REPORT AND RECOMMENDATIONS
by the
ENVIRONMENTAL PROTECTION AUTHORITY

WATERSIDE MANDURAH PROJECT

WATERSIDE MANDURAH
ENVIRONMENTAL REVIEW AND MANAGEMENT PROGRAMME

Bulletin 126

Figure 2 Waterside Mandurah Site Showing foreshore and conservation areas, as proposed, compared with the relevant portion of System 6 recommendation C50.

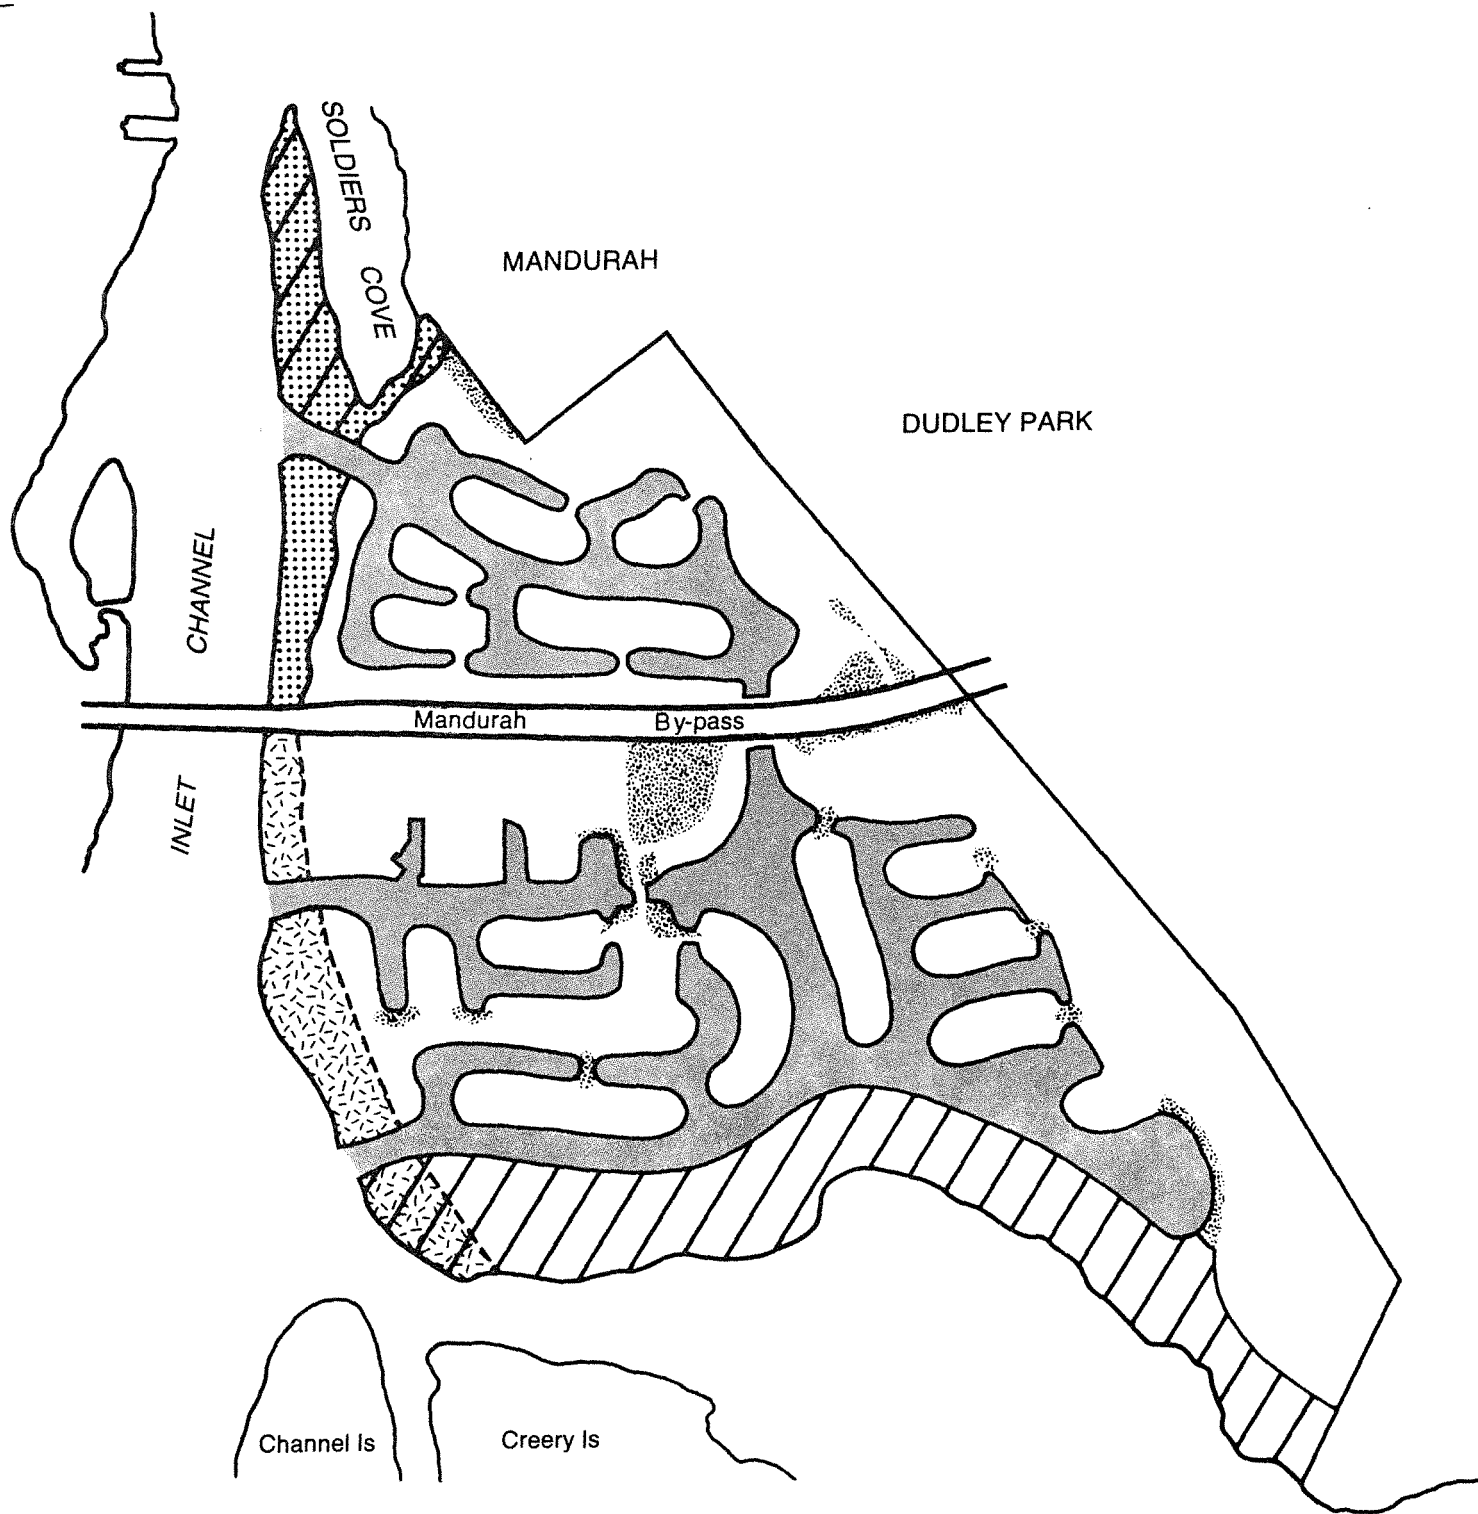
The ERMP states that development of the proposed canals and residential area will result in a completely modified landform. Areas to be left in their natural state will be confined to land around Soldiers Cove in the north and a buffer, 150 - 200 m wide, on the southern margin of the subject land. No objective assessment is given of the values of these areas relative to the areas whose landform is to be completely altered but the ERMP states (p 72) that the samphire zone bordering the tidal area is the most significant area for water birds. In fact, a more significant section may be that subject to winter inundation and used as a winter feeding ground for duck, swans and some wading species. These winter-flooded sections lie outside the proposed conservation buffer (see Fig 2).

The proposed floodways north of the proposed Mandurah by-pass bridge are adequate for the purpose and no change of level should be allowed unless the Public Works Department is satisfied that it would not materially alter the floodway. (See Fig 2).

The proposed foreshore reserve south of the proposed Mandurah by-pass should be regarded as a minimum requirement, with recognition that need for additional land may be identified in subsequent planning. (See Fig 2).
